FISH HABITAT PERMIT FH26-II-0043

RE: Culvert Replacement
Unnamed Pond
Unnamed Stream (Water Body No. 212-10-10020-2019-3005)
Section 17, T 16 S, R 1 W, CRM
Location: 60.48425 N, 145.43273 W
ADF&G Culvert No. 20103769

Pursuant to the Anadromous Fish Act at AS 16.05.871(b) and the Fishway Act at AS 16.05.841, the Alaska Department of Fish and Game (ADF&G) Habitat Section has reviewed your proposal to replace and relocate a culvert at the intersection of Sheridan Glacier Road and the Copper River Highway (milepost 13.7).

PROJECT	1162.63781.01
DATE	JANUARY 2026
© DOWL 2026	
SHEET	
C10 OF C16

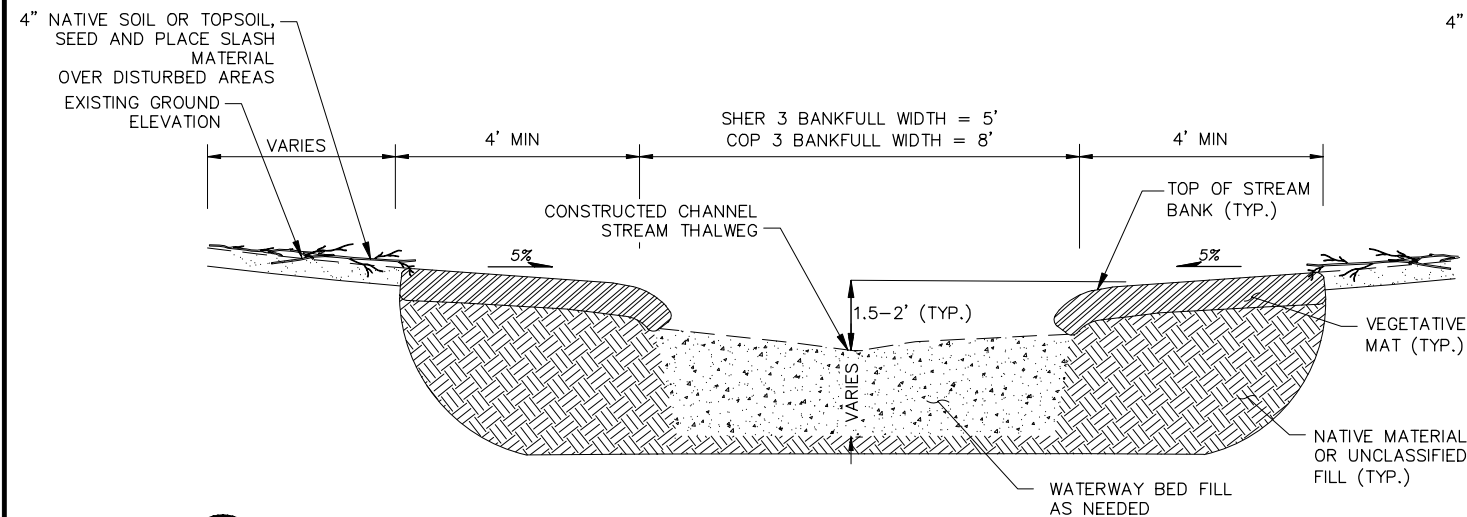
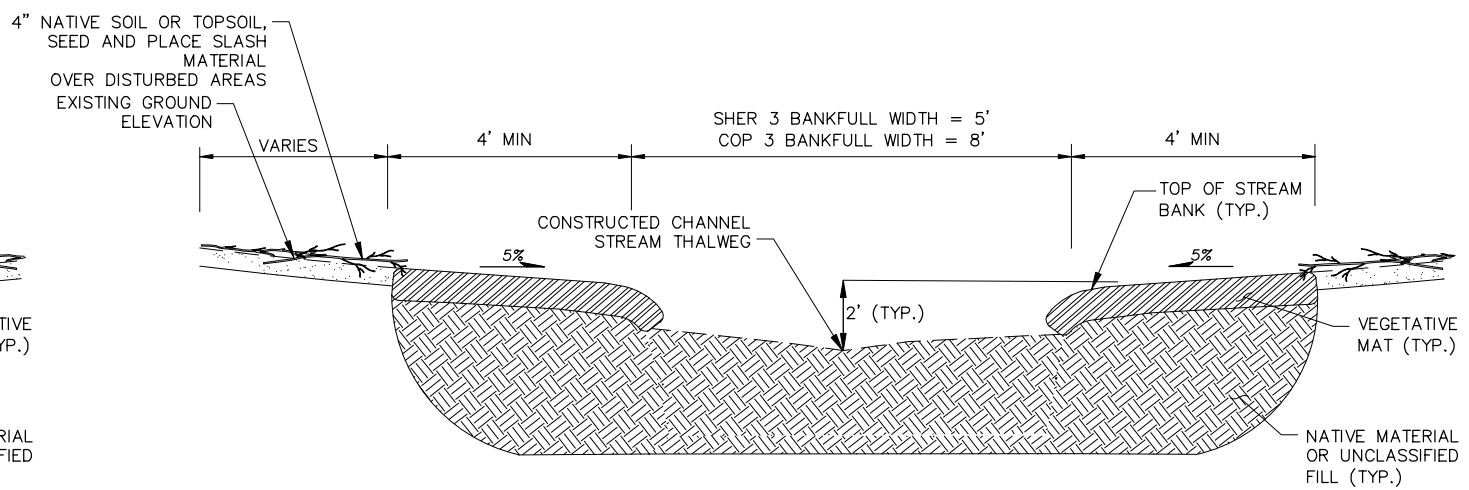
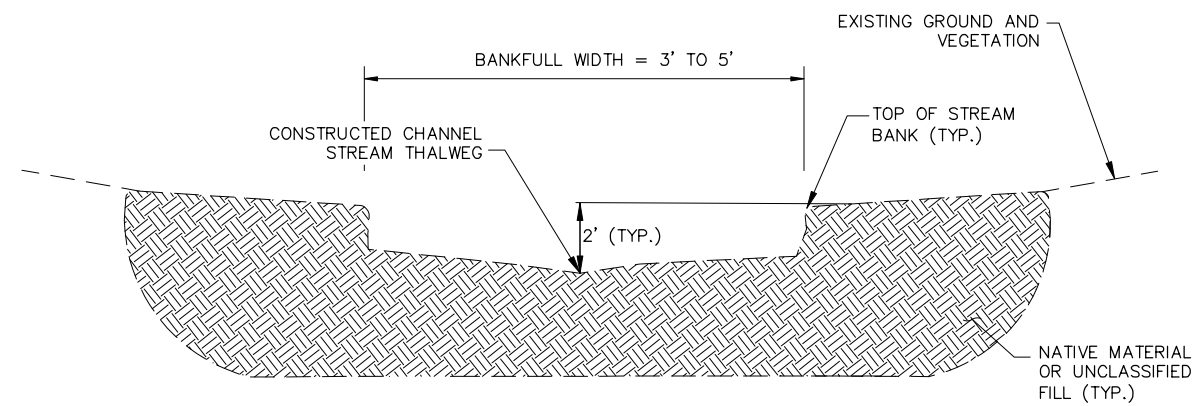
Disturbed areas upstream and downstream of the culvert will be restored using salvaged organic material, vegetative mats, and wetland plugs (Sheet C-10). Voids in rip rap will be filled with salvaged soil and covered with topsoil and native seed mix.

1. In-water work in the flowing water of the creek shall be completed between June 1 and August 15 unless otherwise authorized by the Habitat Section.
2. The new culvert shall be installed and maintained to accommodate the efficient passage and movement of fish both upstream and downstream.
3. Work areas shall be isolated from the flowing waters of the Sheridan Glacier River tributary at all times during construction.
4. Dewatering or bypass pump intakes shall be surrounded by a properly sized and screened structure when used in areas which may support fish. The screen mesh shall not exceed 1/8th inch, and the water velocity at the screen surface shall not exceed 0.5 feet per second.
5. A plan for diversion, construction sequencing, and stranded fish rescue shall be submitted to the Habitat Section a minimum of 2 weeks prior to construction for review and approval.
